# PERMIT

## SEWAGE DISPOSAL SYSTEM

#### HOWARD COUNTY HEALTH DEPARTMENT

P 49177

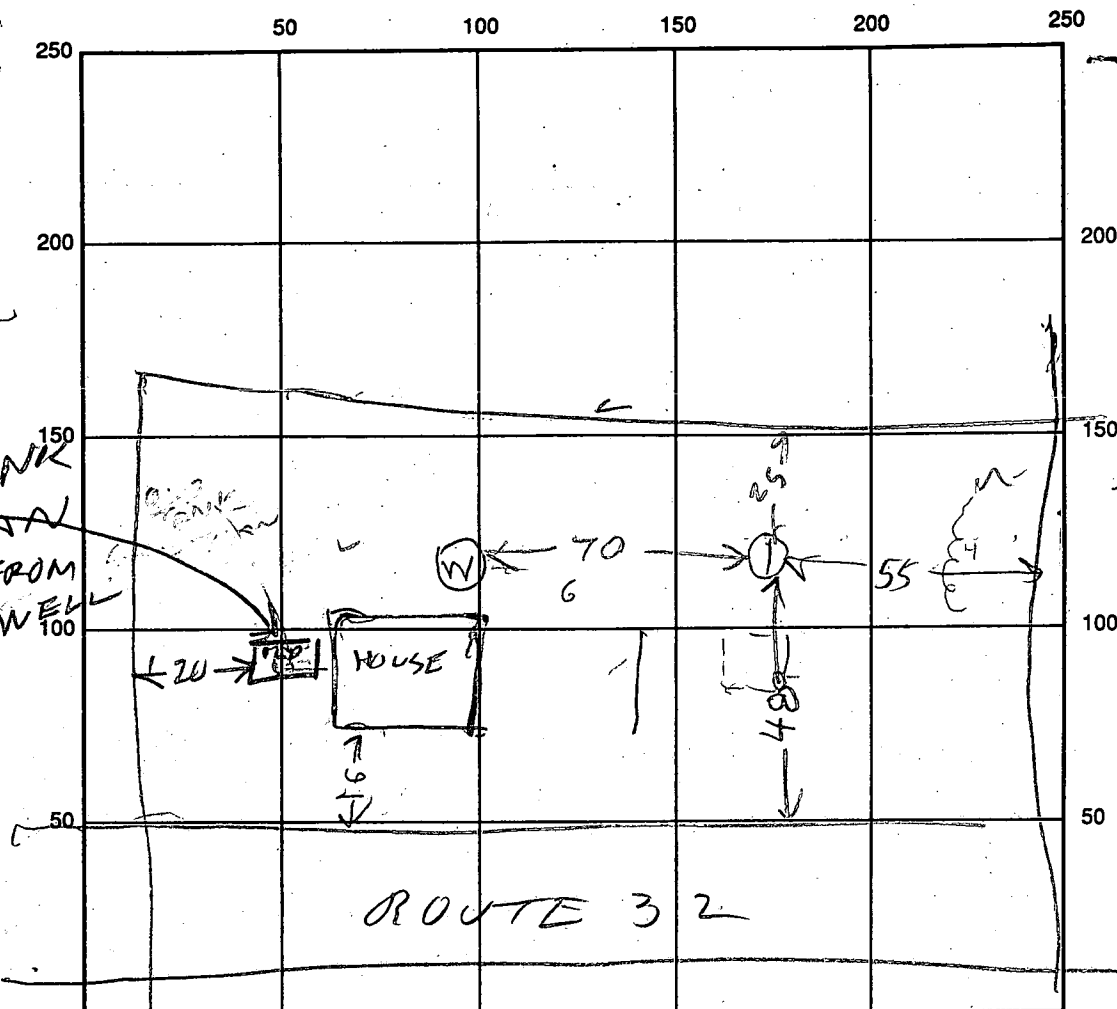
OLD TANK  
LESS THAN  
50 FT FROM  
DRILLED WELL

VERY CONFINED AREA MUST HAVE TRENCHES ABOUT 70  
FT FROM WELL. TANK TO BE ONLY 60 FT FROM WELL  
BUT TOP SEAM TANK TO BE USED. EXISTING STEEL TANK  
LESS THAN 50 FT FROM WELL & MUST BE REPLACED

Paper septic Area not known, New well in Driveway  
Hand dug well must be abandoned - SFB
